Crystal River Unit 3
Docket No. 50-302

April 8, 1996
3F0496-04

Subject: Technical Specification Change Request No. 203, Revision 2, Notifications
Required Prior to MODE 4 and Responses to Request for Additional
Information

GROWTH RATE INFORMATION

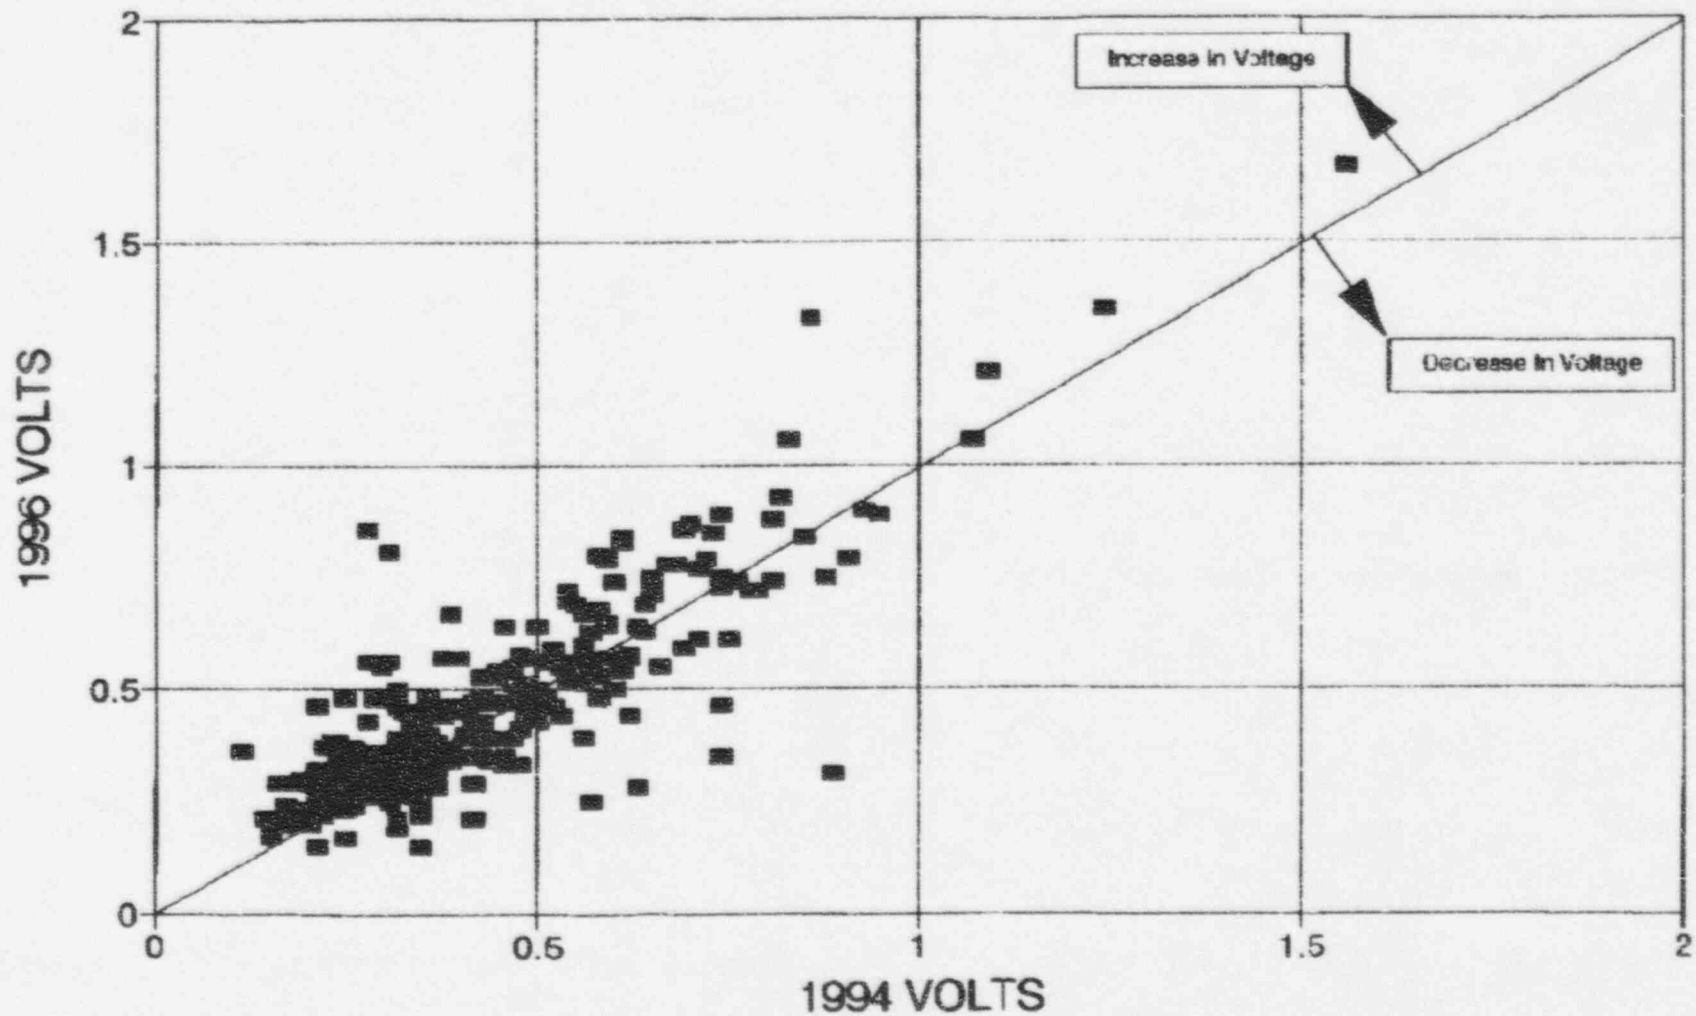
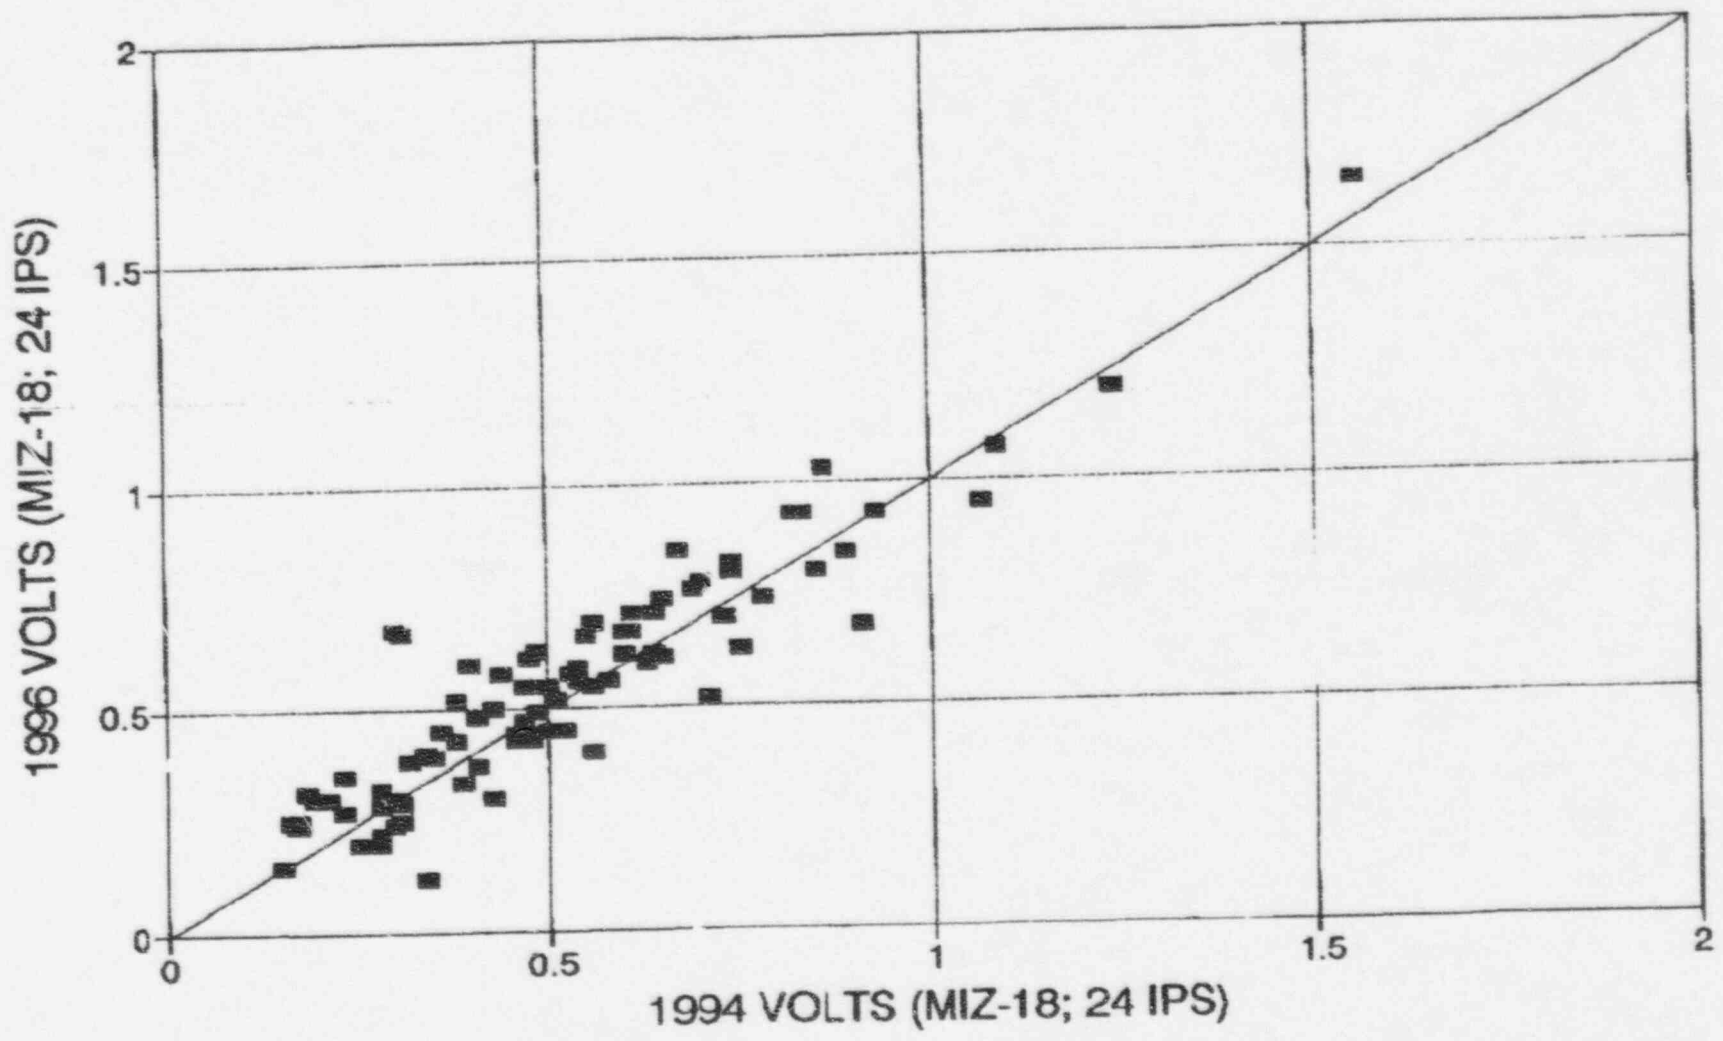
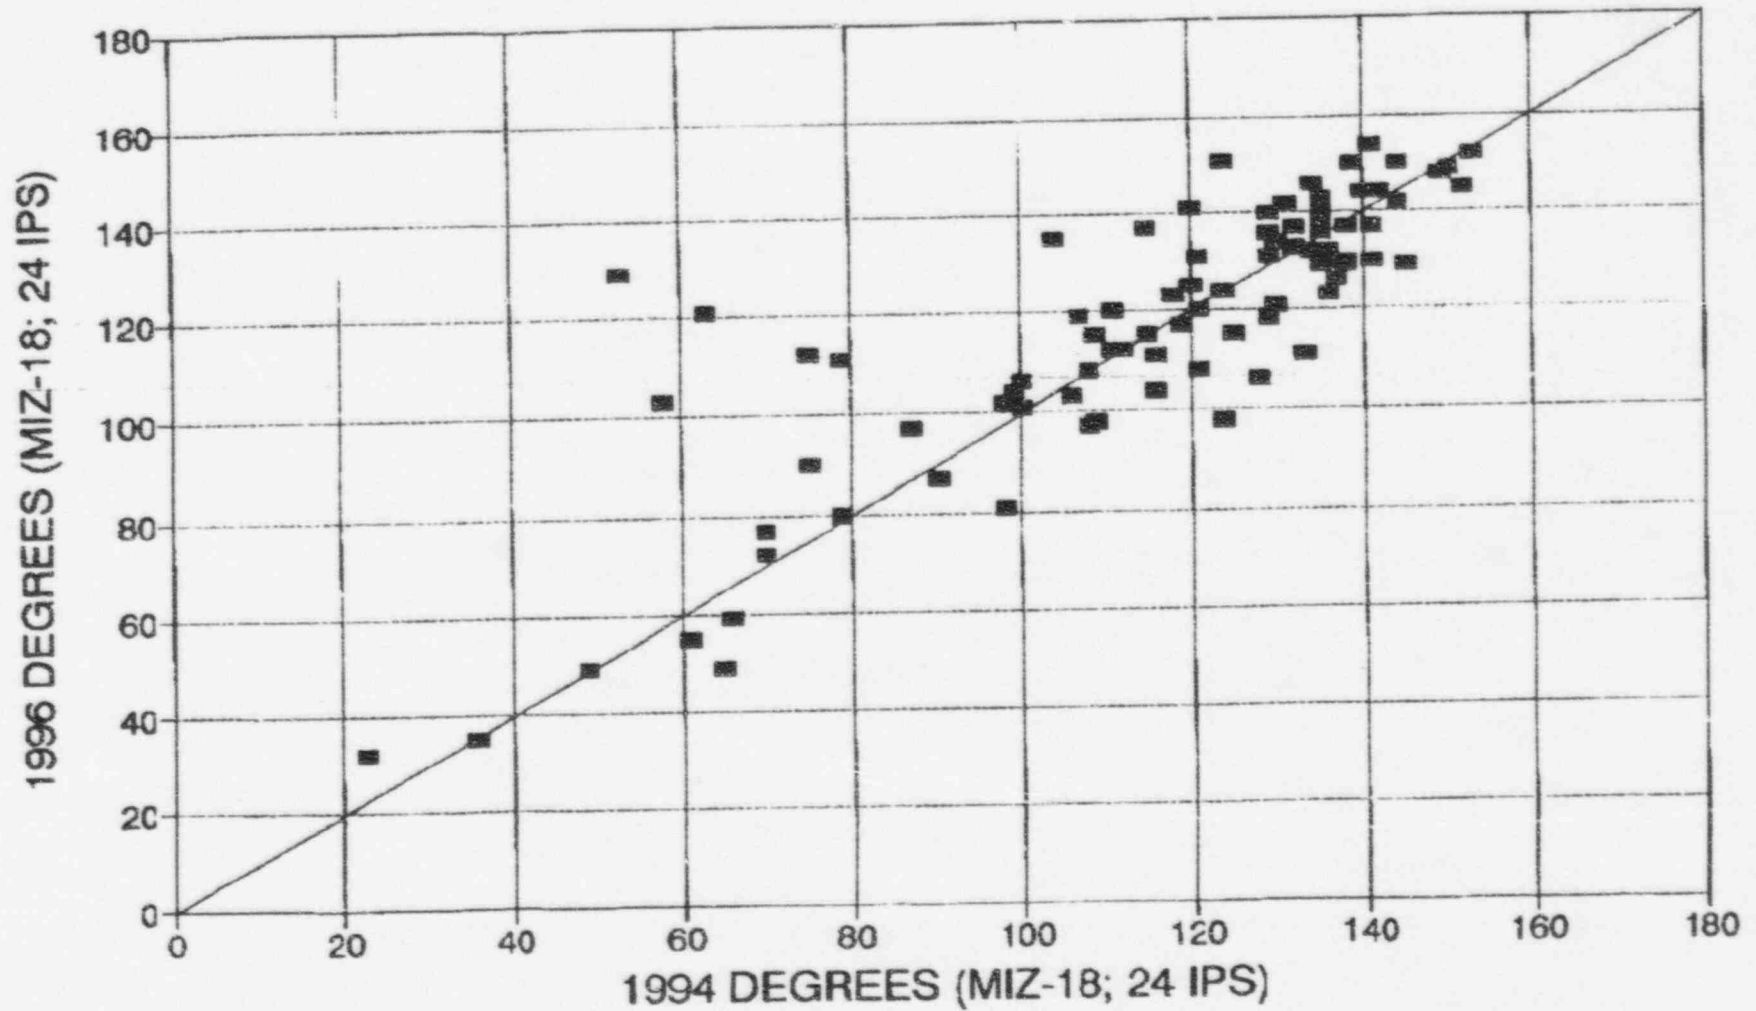
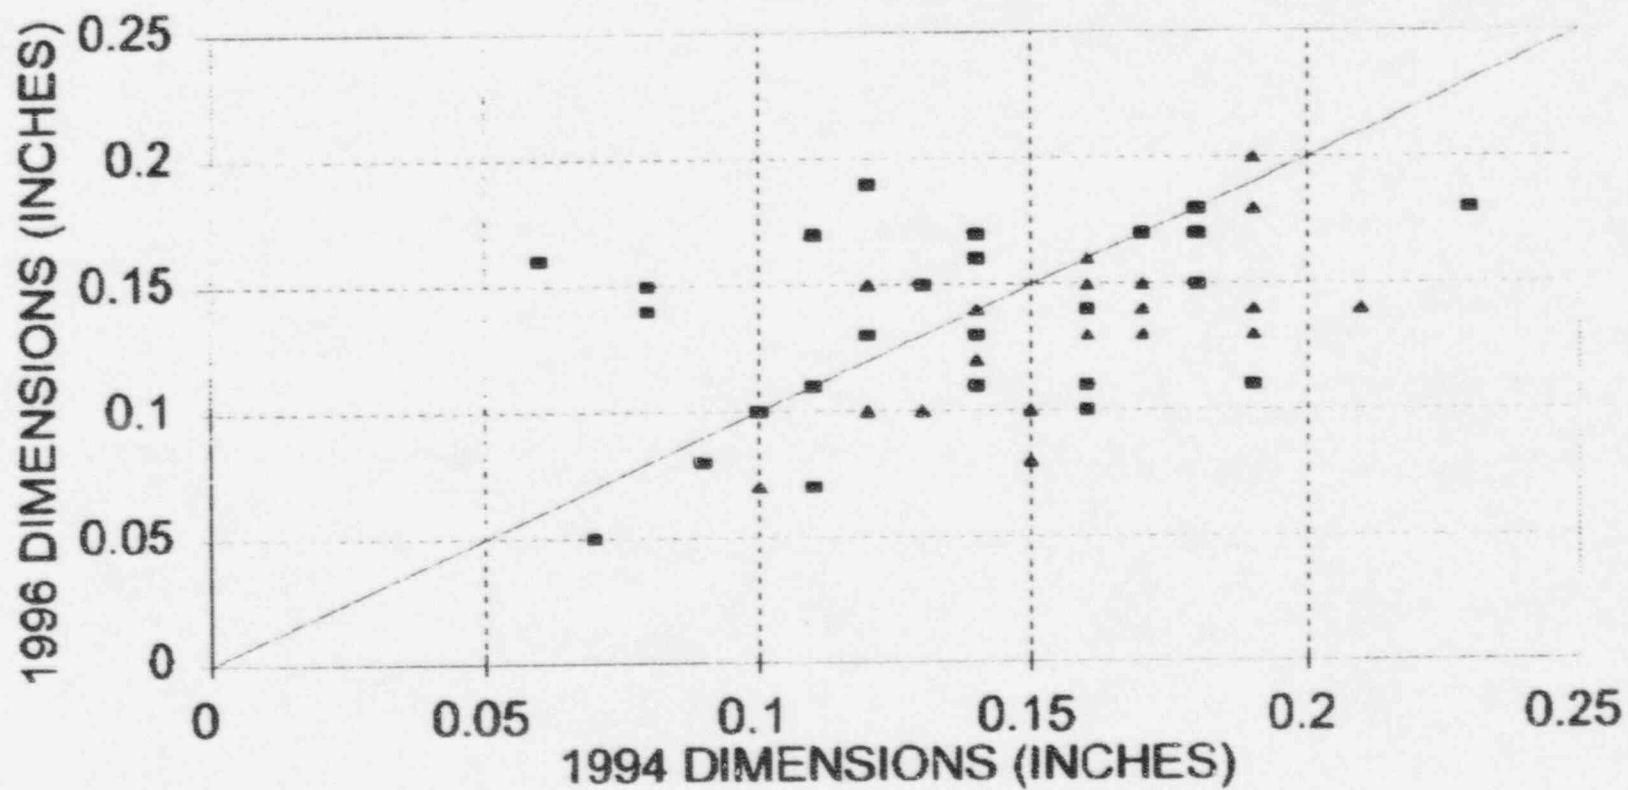
- o Provide a growth rate assessment including the use of both length and voltage arguments of indications from the 1994 OTSG tube inspections and indications from the 1996 OTSG tube inspections. The growth rate studies are provided in Attachment 1. Several exhibits and their purpose are presented within the attachment. As mentioned previously, these exhibits conclude there is no growth in the population of first span IGA indications.

- 3) In order to provide an assessment of growth of the first span indications, the following exhibits are included as Attachment 1.
 - 1994 voltage versus 1996 voltage for first span indications - 10R general inspection results

The attached exhibits are rather self-evident, but a few items of explanation are necessary. Prior to beginning the 10R CR-3 OTSG eddy current examination, FPC ran a comparison study between the ZETEC MIZ-18A and MIZ-30-8 eddy current instruments and setup. The purpose of this study was to assure comparability of previous outage results with those obtained using the newer inspection hardware setup. Eighty five (85) first-span indications were included within the scope of this study. Each of these indications was initially inspected with the MIZ-18A setup. This data was obtained using the same essential variables for acquisition and analysis as used during the 1994 CR-3 outage. The 1996 MIZ-18A to 1994 MIZ-18A data comparison shows essentially no growth. The scatter of the data about the zero growth line is easily bounded by the acquisition variability observed for new probes (previously provided to the Staff in Reference 1). The general 1996 to 1994 voltage comparison was based on data obtained with both MIZ-30-8 and MIZ-18A set-ups. Based upon the results of the comparison study performed prior to the outage, the MIZ-30-8 set-up produces slightly higher voltages than does the MIZ-18A. This difference essentially envelopes the scatter in the 1994 to 1996 general comparison.

The length and width study included all first-span indications which received MRPC inspection during the last two outages. The data is scattered rather evenly about the line of zero growth. The larger degree of scatter in this data is attributed to the analysis variability associated with the clip plot sizing technique, particularly for smaller indications. It is noted that the indications which experienced the largest increase in magnitude from 1994 to 1996 were the smaller indications observed during the 1994 examination. The largest 1994 indications consistently exhibited a lower extent measurement during the 1996 outage. In comparison with previous outages, the scatter in this years' data is less than in the past. This is attributed to the special attention to detail paid to the sizing of indications during 10R (Only the Level III analysts performed this function during 10R and they were qualified with a practical performance demonstration test which included clip plot demonstration).

The results of the various plots all support FPC's previous assessment of 'no growth' for the population of first-span IGA indications.

10R FIRST SPAN VOLTAGE DISTRIBUTION

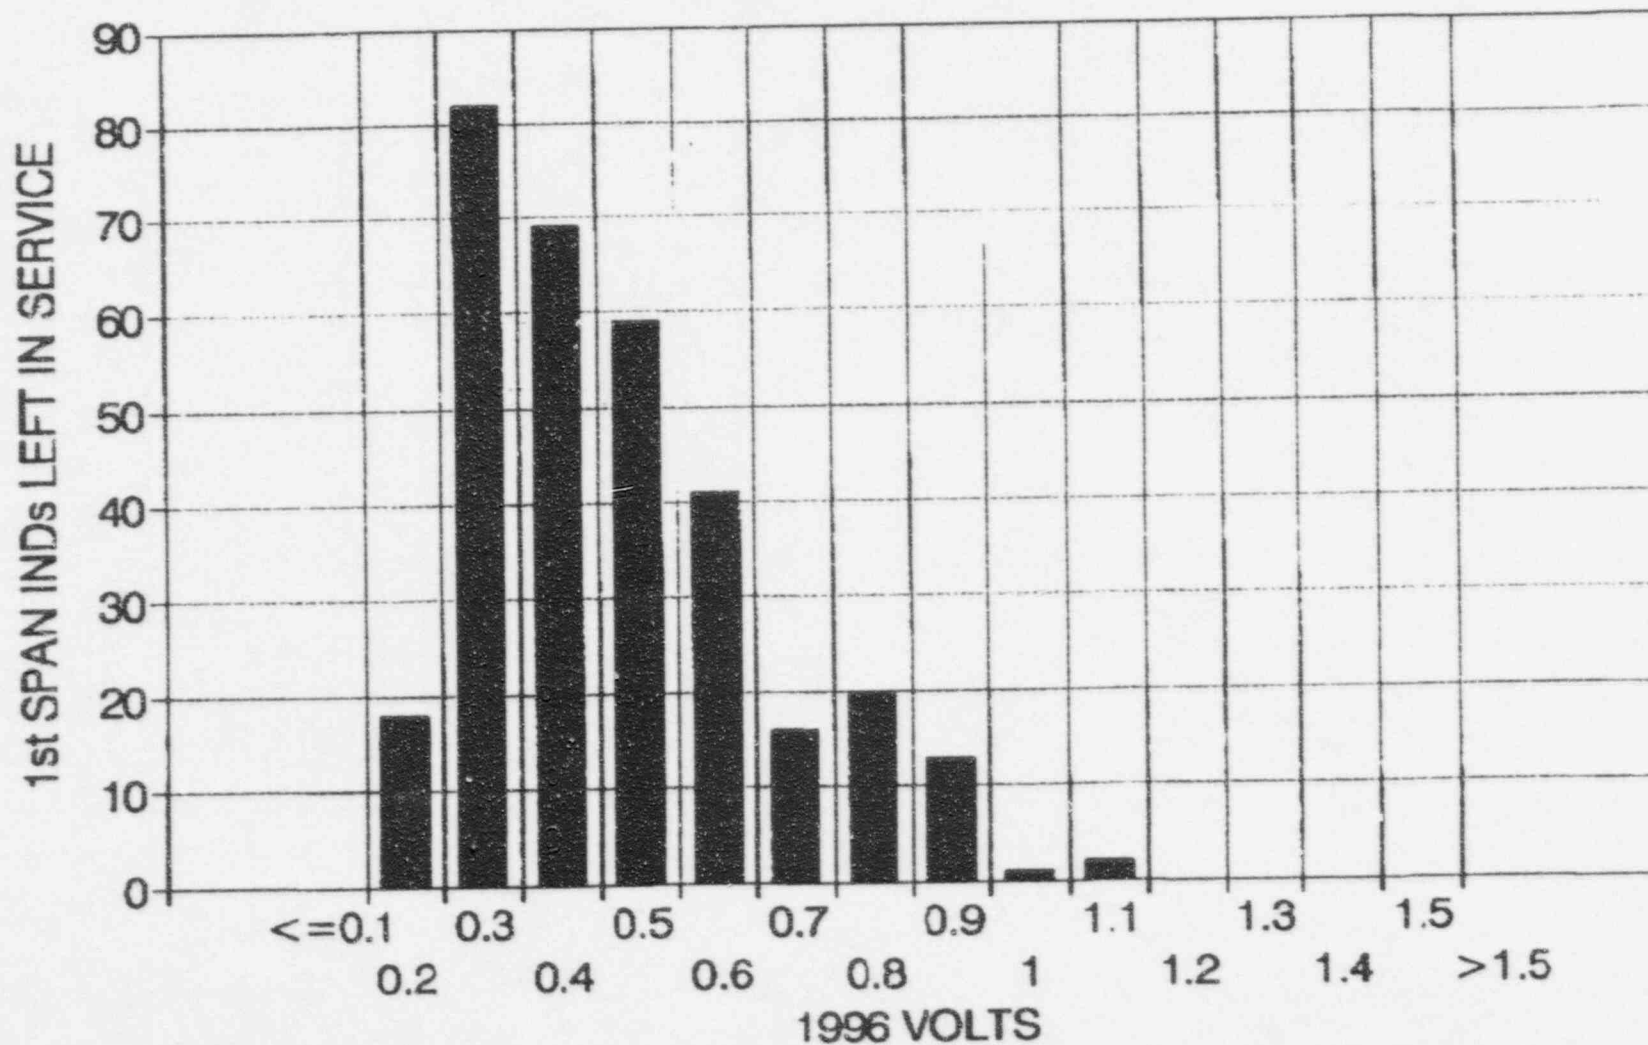
- o Provide the basis for target test pressure, sample selection, and results of in-situ pressure testing. Provide a discussion about why this test is bounding. This information is provided in Enclosure 1. Attachment 3 presents the Refuel 10 first span voltage versus occurrence distribution.

Attachment 3 is the 10R first-span voltage versus occurrence distribution. This distribution, even assuming an additional 20% uncertainty applied to all the data, shows there is a low probability of having any indication left in service which would exceed the proposed 1.25V criteria. Growth rate information presented previously within this response indicates the same conclusion would apply at the end of the upcoming operating cycle.
